# INVESTIGATION OF THE MARCH 22, 2012 PARTIAL BUILDING COLLAPSE DURING DEMOLITION AT 604-606 WEST 131<sup>ST</sup> STREET, NEW YORK, NY

U.S. Department of Labor  
Occupational Safety and Health Administration  
Directorate of Construction

July 2012

Figure 2 Second Floor Demolition Plan (Mr. Shapiro's drawing DM-005.00)

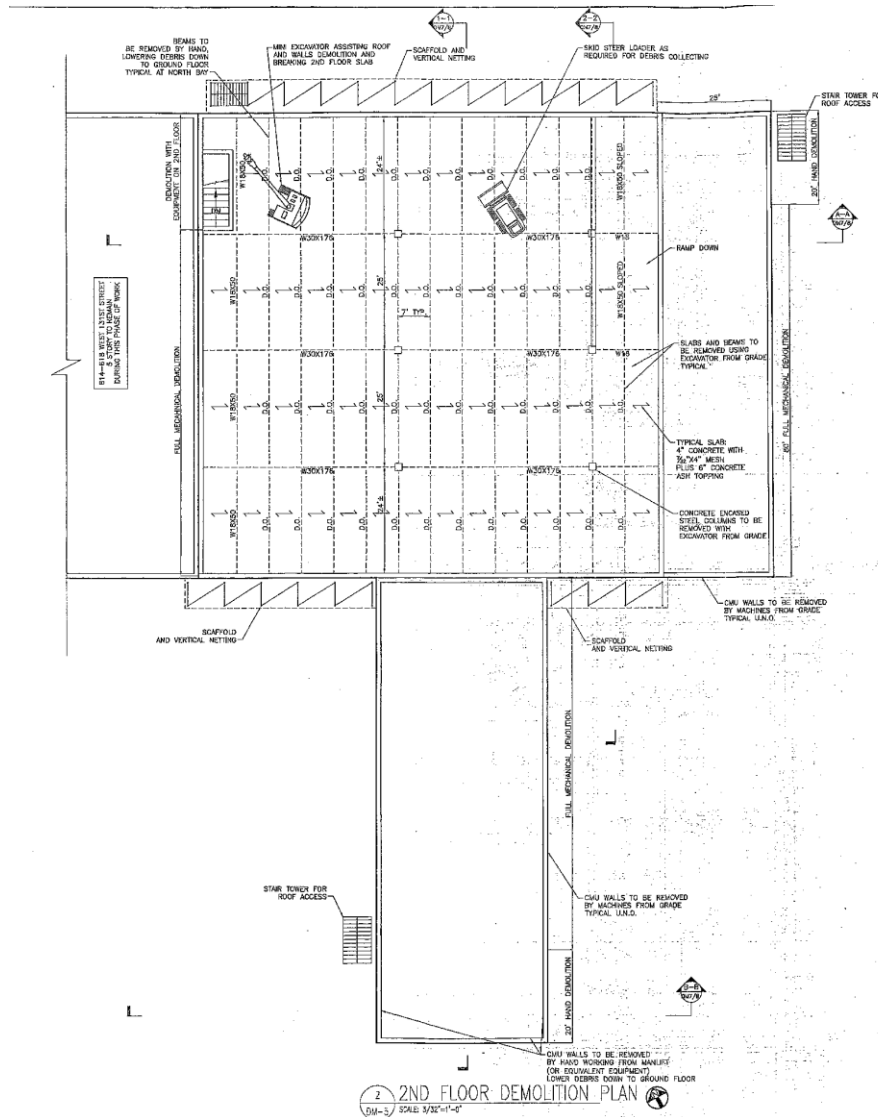
The following observations were made concerning the demolition drawings DM-005.00 (Figure 2) prepared by Shapiro.

- Drawings were prepared without reviewing the original building drawings available at the New York City Department of Building (NYCDOB).
- The beam and girder sizes did not reflect the correct sizes as shown on the original document. The original girder size was 30BG200 against an indicated W30x176.

Similarly, the original filler beam size was 18BI48 ½ against indicated W18x50. The discrepancies in the sizes did not create any hazard.

- The girders were shown from column to column. No splice connection on the girder was indicated. This was the major contributing factor to the collapse.
- The concrete floor slab thickness was shown as 4” plus 6” of ash concrete. No core drilling was performed to calculate the actual slab thickness.
- The demolition drawings did not provide specific instructions for removal of individual structural framing members such as beams, girders, and CMU walls. It only specified demolition tier-by-tier.

5. The consultant's drawings showed the framing of the building which did not represent the actual framing, thus misleading the contractor. This contributed to the collapse.

Figure 11 Existing Shear Splice Connection Detail

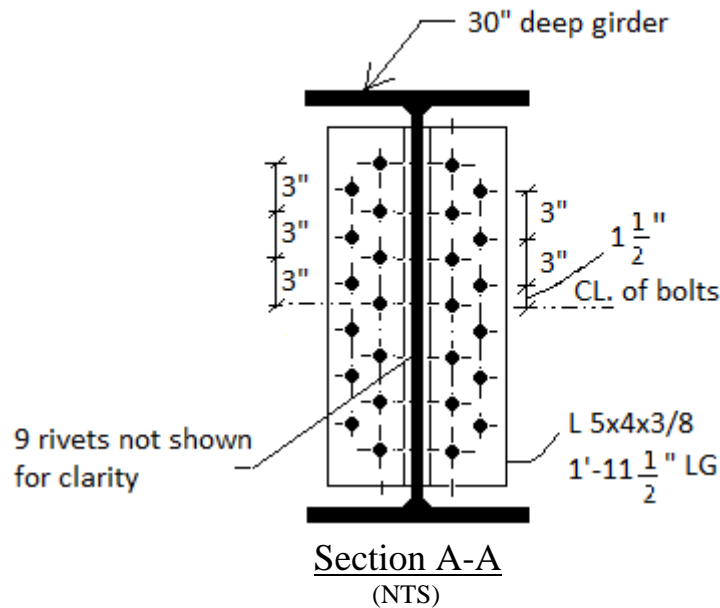
Of greater interest to this investigation was the analysis of the girders on column lines B and C, between column lines 3 and 1. The girder on column line B was continuous from column 3 and extended approximately 8 feet beyond column 2, where it was connected to another girder that spanned up to column line 1. The girder on column line C had a similar arrangement. The existing structural drawings available did not contain the details of the splice connection between the two girders. However, the splices were preserved at the site and were examined, post-incident, to obtain relevant information. Two angles, 5x4x3/8 were riveted to the web of the girders with 9 rivets. The outstanding 5" legs were bolted back-to-back with 13 bolts, see Figure 10. There were no connections between the flanges of the two girders, rendering the connection devoid of any moment capability. Hence, it was a customary hinged connection.

Next, the capacity of the splice to resist flexure was evaluated. It was determined that although the splice was designed as a hinge, it could have had some capacity to resist flexural moment. It was determined that the splice could only resist approximately 50% of the imposed moment. Under the imposed load, the  $\frac{3}{4}$ " bolts were subjected to shear and tensile loads. The bolts on the column line C girder splice were subjected to stresses well beyond their ultimate capacity of 45 ksi, and hence contributed the failure.
